**The Wilderness Society et al. Comments on the
U.S. Forest Service Mountain Valley Pipeline and
Equitrans Expansion Project Draft Supplemental
Environmental Impact Statement (#50036)**

EXHIBIT 14

**Compilation of Virginia DEQ Inspection Reports - Mountain Valley Pipeline
Spread G - 2021 and 2022**

Assembled by Wild Virginia, February 17, 2023

Figure 1 - sites of reported sediment deposits in streams and wetlands along MVP's path

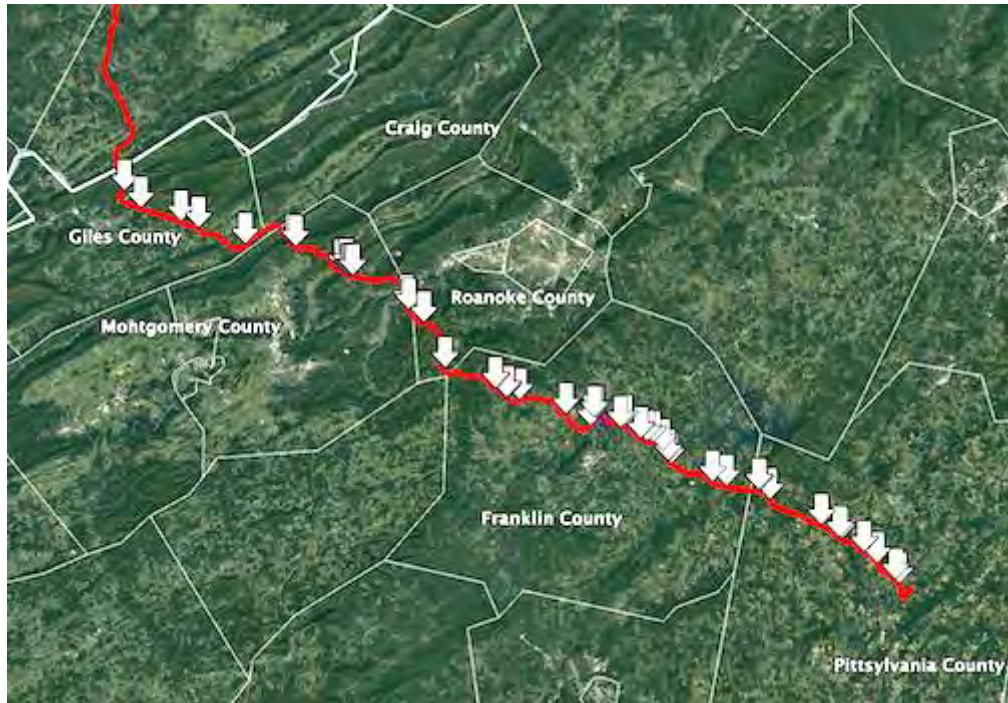
These pollution events violate state law in at least two ways. First, as explained in Virginia's enforcement lawsuit against MVP, those that impact waterbodies are unpermitted discharges under the State Water Control Law and Virginia Water Protection Permit regulations. Second, Virginia's Erosion and Sediment Control regulations state that both "[p]roperties and waterways downstream from development sites shall be protected from sediment deposition. . . ." 9 VAC 25-840-40(19).
